Proposal for the 05 series of amendment to UN Regulation No. 46 (Devices for indirect vision)

The modifications to the current text of UN Regulation No. 46 are marked in bold for new characters and strikethrough for deleted characters.

Figure 11

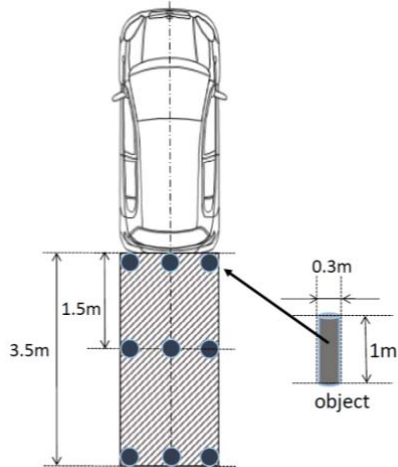
Insert new paragraphs 15.2.4.8. to 15.2.4.8.2., to read:

"15.2.4.8. Class VIII close-proximity rear-view device

15.2.4.8.1. The field of vision shall be bounded by the following planes and shall be such that the driver can see at least part of each cylindrical objects with a height of 1,000 mm and a diameter of 300 mm which is located at 6 positions within the boundaries of the field of vision as defined in Figure.11:

(a) A transverse vertical plane of the outermost point of the rear of the vehicle;

(b) A transverse vertical plane [3,500] mm behind the outermost point of the rear of the vehicle;

(c) Two longitudinal vertical planes parallel to the longitudinal vertical median plane of the outermost point of the side of the vehicle.

Insert new Figure 11:

" Class VIII field of vision
